CITY OF NEW BEDFORD
MASSACHUSETTS
CONSTRUCTION OF
SIDEWALK / DRIVEWAY

Driveway Review Form

Address: 217 Grinnell st

Driveway Review

Sketch

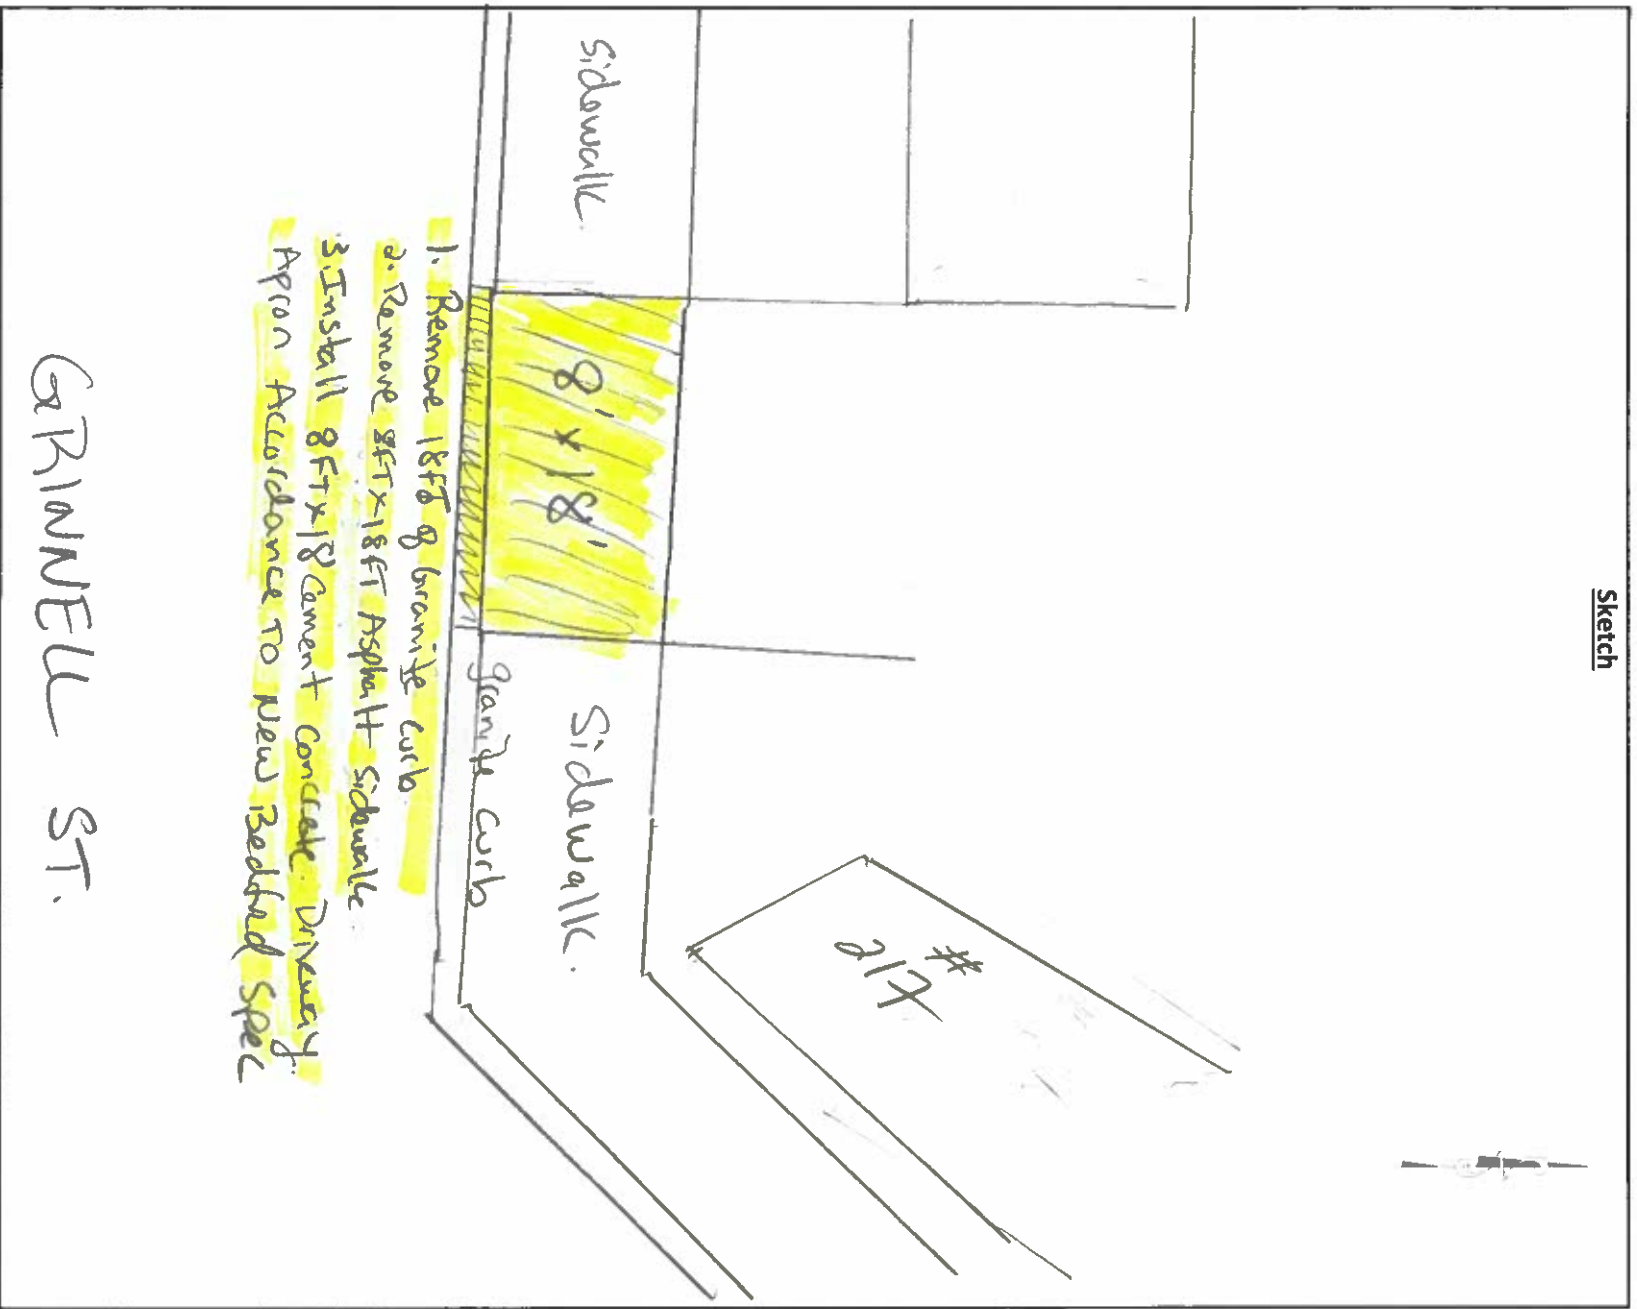
Approved
8ft City layout

18' Curb cut
Install 8x18 Concrete
Apron
